# Steven M. Clouse WRC Primary Clarifier Rehabilitation Project

Mandatory Pre-Bid Meeting  
October 27, 2021 – 10:00 AM

# Addendum No. 4 Overview

# Project Details – Primary Sludge and Skimming Pump Station Canopy Demolition

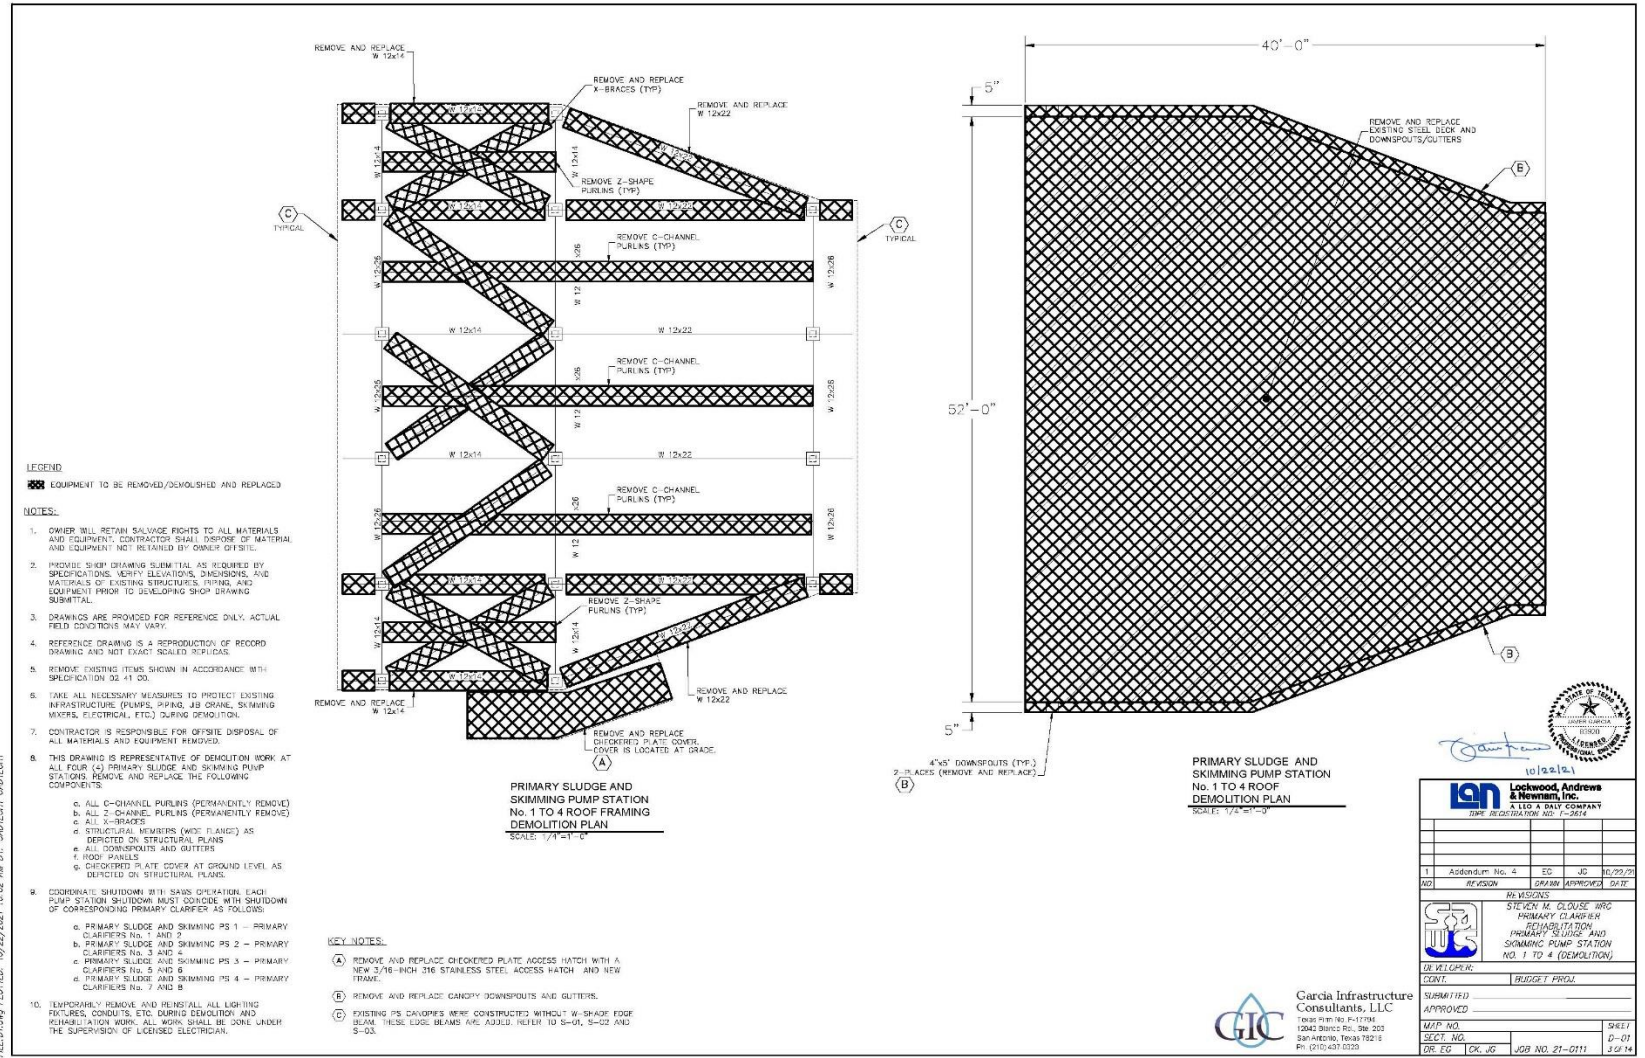
1. Work applies to Primary Sludge and Skimming Pump Station No. 1 to 4.
2. Contractor is responsible for the offsite disposal of all materials.
3. Drawing shows **structural members** to be removed and replaced.
4. All **purlins** are to be permanently removed and not replaced.
5. **Roof panels** to be removed and replaced.
6. **Downspouts and gutters** to be removed and replaced.
7. Temporarily remove and re-install all **light fixtures, conduits, etc.** during demolition and rehabilitation work and re-install under the supervision of a licensed electrician.
8. Remove and replace **checkered plate cover and frame.**

# Project Details – Primary Sludge and Skimming Pump Station Demolition

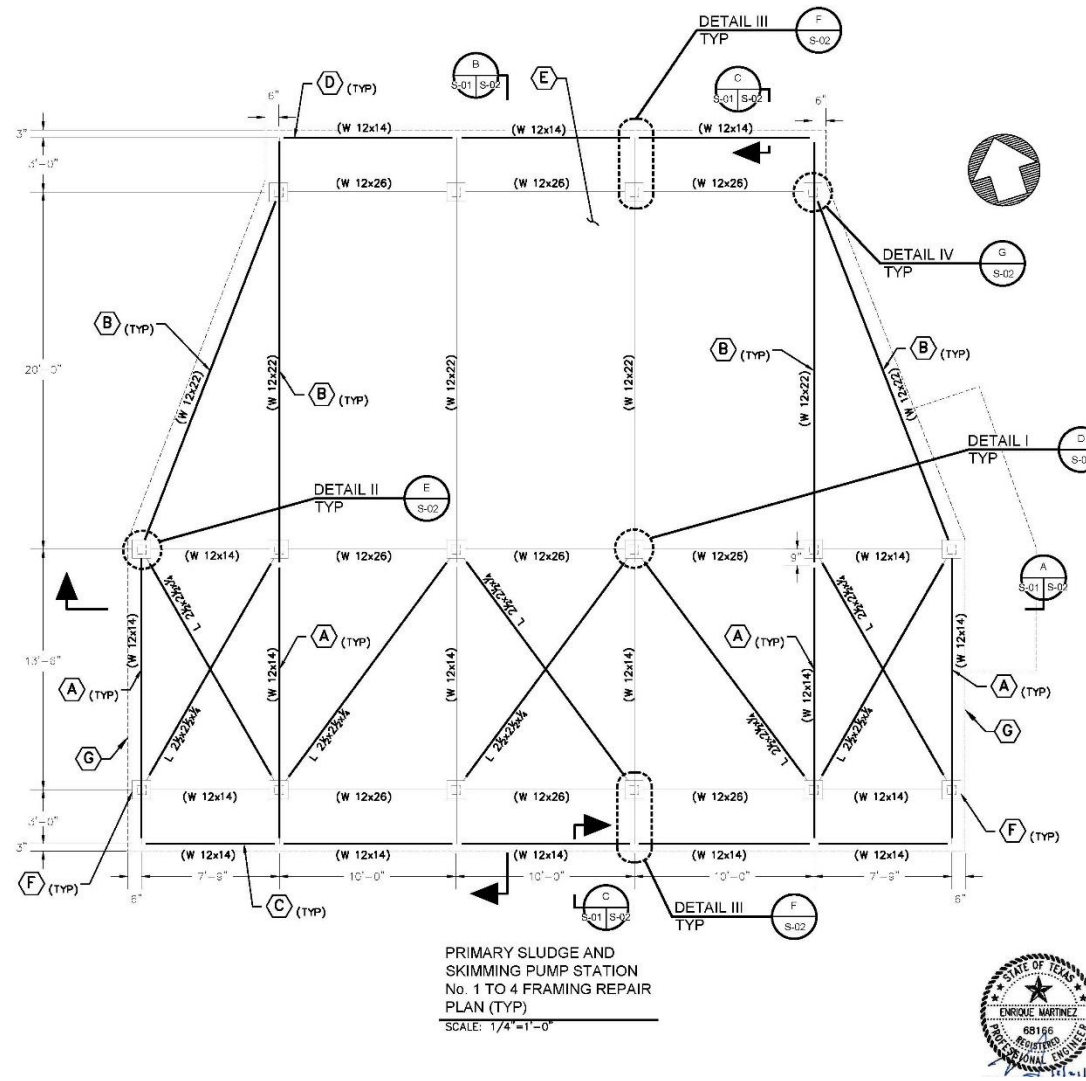
**KEY NOTES:**  
 (A) REMOVE AND REPLACE CANOPY DOWNSPOUTS AND GUTTERS  
 (B) REMOVE AND REPLACE STRUCTURAL MEMBERS  
 (C) REMOVE AND REPLACE X-BRACING  
 (D) PERMANENTLY REMOVE Z SHAPE PURLINS  
 (E) PERMANENTLY REMOVE C-CHANNEL PURLINS  
 (F) REMOVE AND REPLACE METAL ROOF PANELS  
 (G) REMOVE AND REPLACE CHECKERED PLATE COVER

# Project Details – Primary Sludge and Skimming Pump Station Rehabilitation

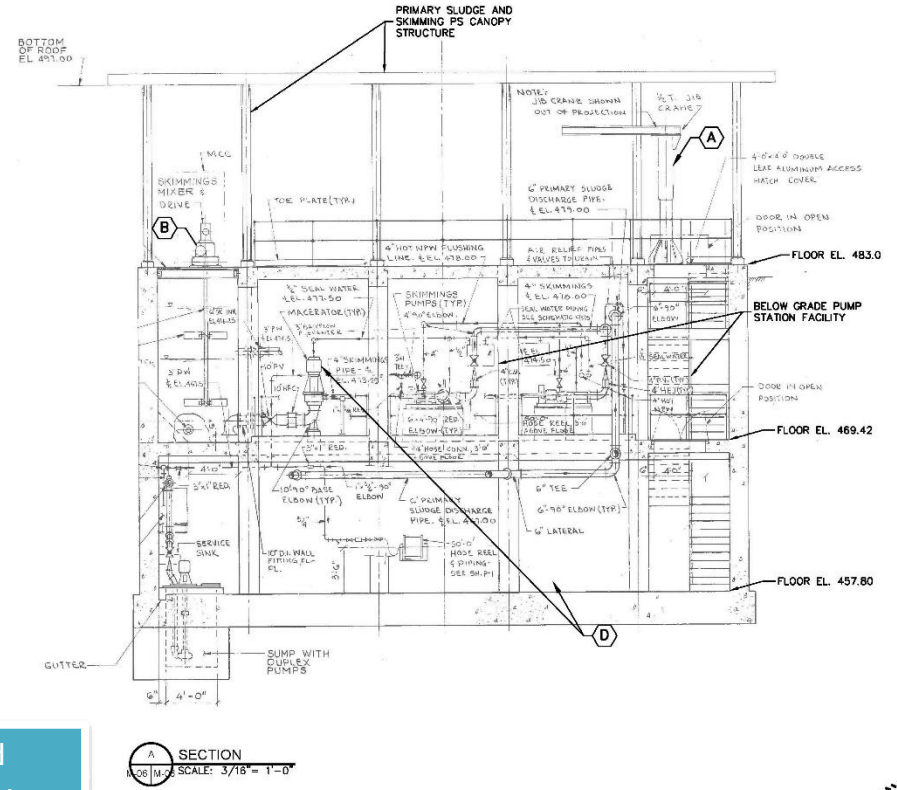
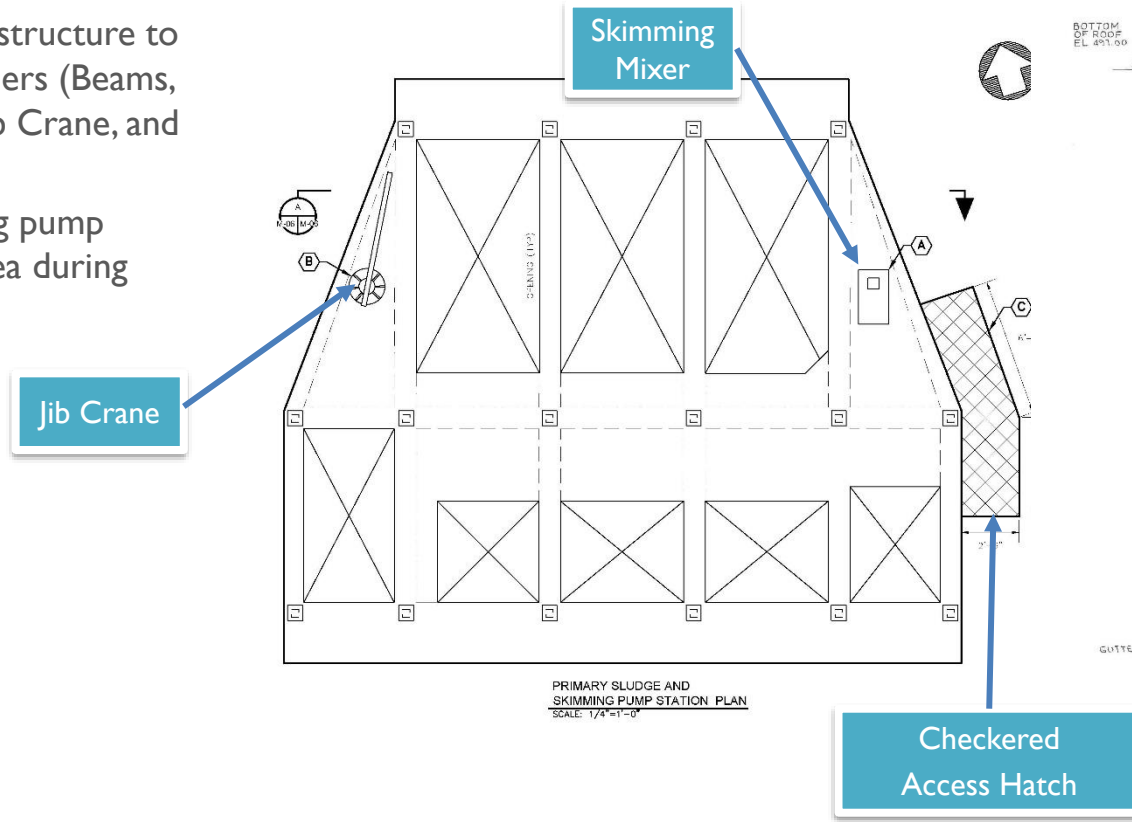
1. Sandblast and coat canopy structure to include all structural members (Beams, X-Braces, and Columns), Jib Crane, and Skimming Mixer.
2. Shroud and protect existing pump station and surrounding area during sandblasting and painting.

# Project Details – Clarifier Effluent Channel Diffuser System (Air Header)

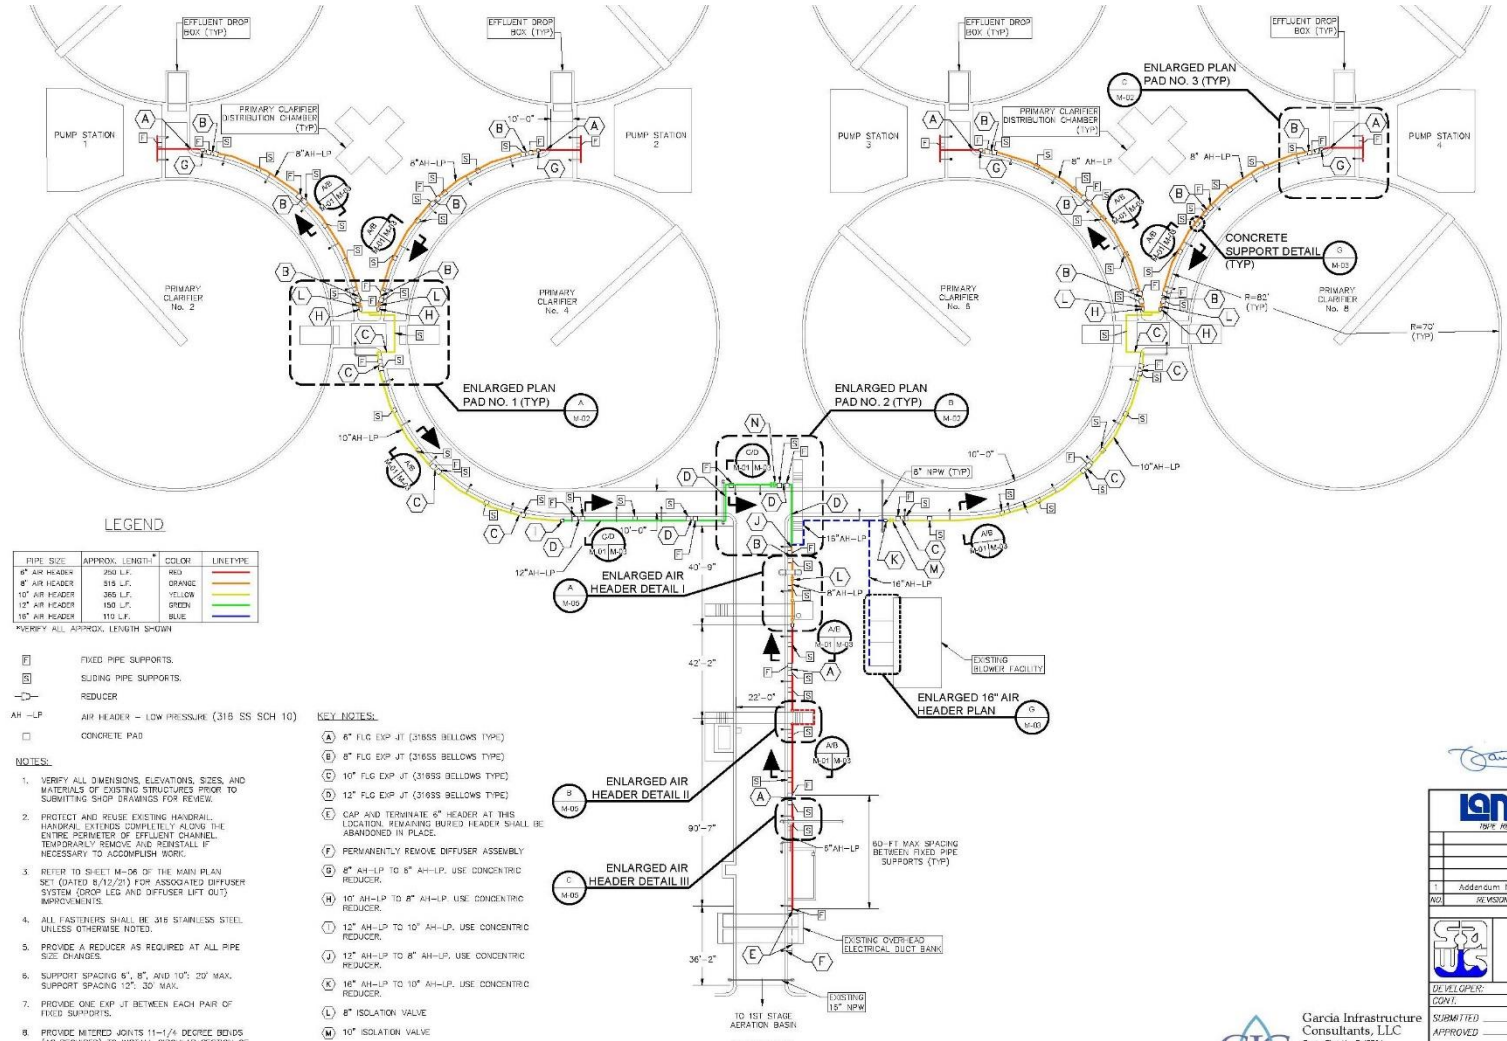
1. Abandoned existing buried air header and replace with a new above grade air header. Pipe size ranges from 16, 12, 10, 8, and 6-inch.
2. Air header– 316 SS (Schedule 10S)
3. Pipe adjustable pipe supports- 316 SS.
4. Expansion Joints (Bellows Type)- 316 SS.
5. Isolation Valves-
  - Body- Cast Iron
  - Disk- 316 Stainless Steel
6. Header Pipe Supports
  - 20-ft spacing between supports.
  - One (I) expansion joint between fixed supports.
  - Provide sliding supports between fixed supports.
7. Enlarged plans provided to highlight resolution of conflicts.

# Project Details – Clarifier Effluent Channel Diffuser System (Air Header)

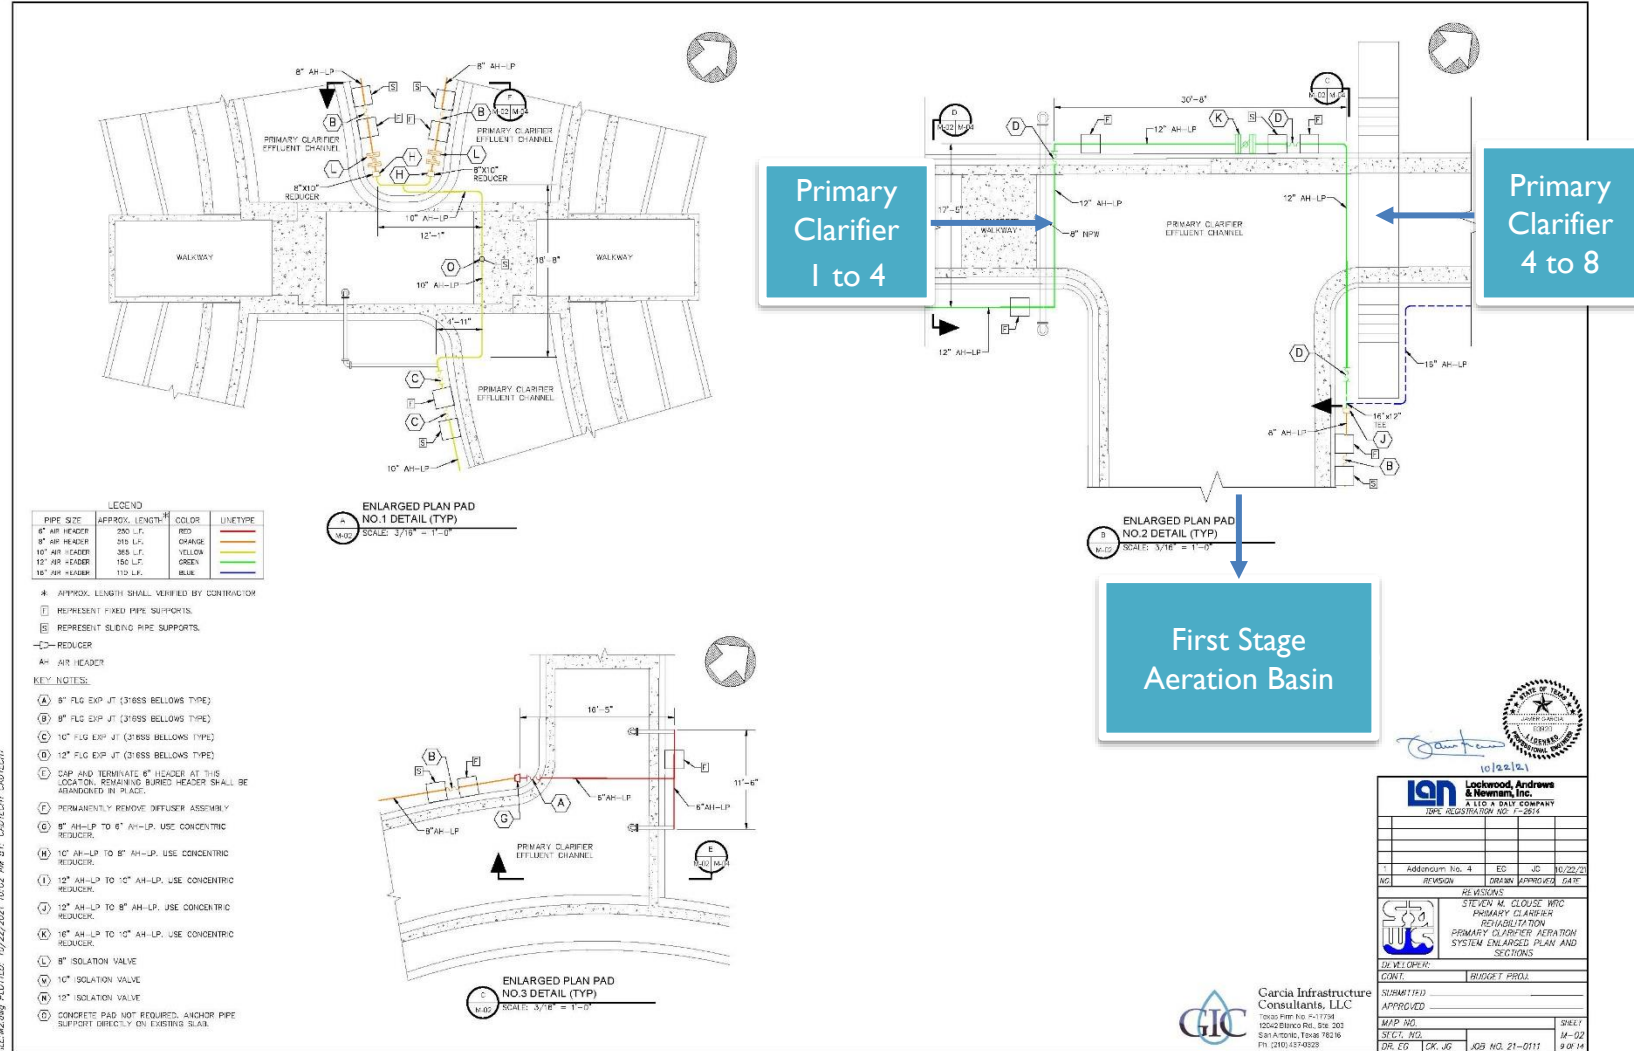
- 1. Enlarged plans show alignment at clarifier drop boxes and other junction points.

# Project Details – Clarifier Effluent Channel Diffuser System (Air Header)

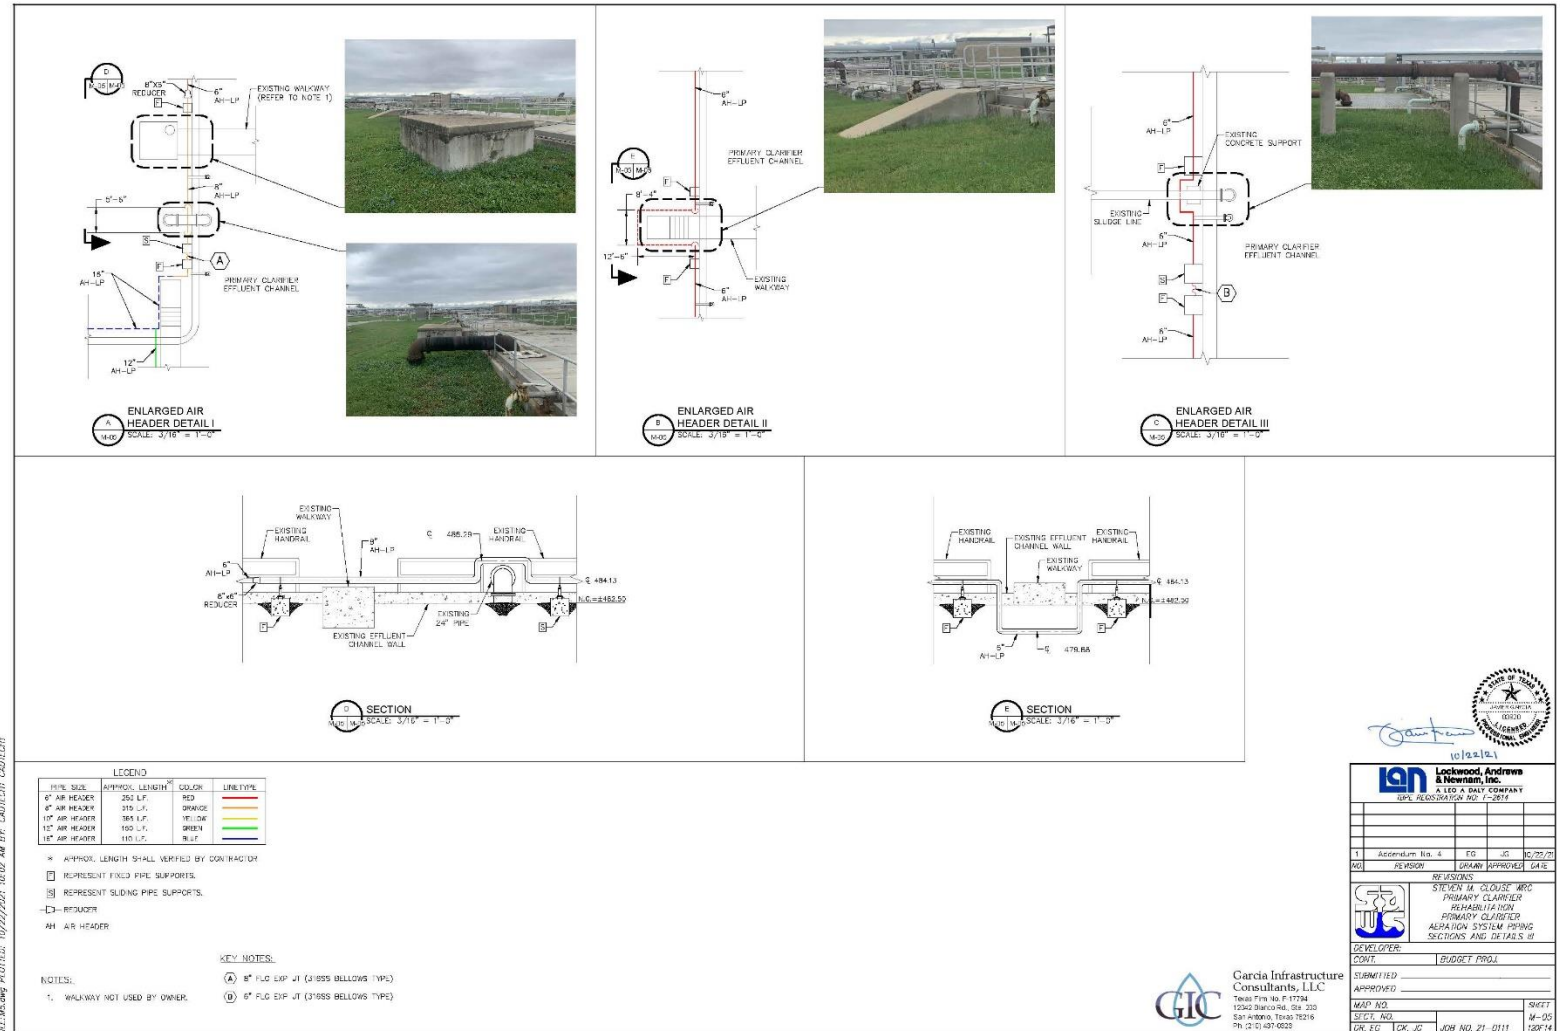
I. Enlarged Plans depict conflict resolution along the common Primary Clarifier Effluent Channel from the Junction point to First Stage Aeration Basin.
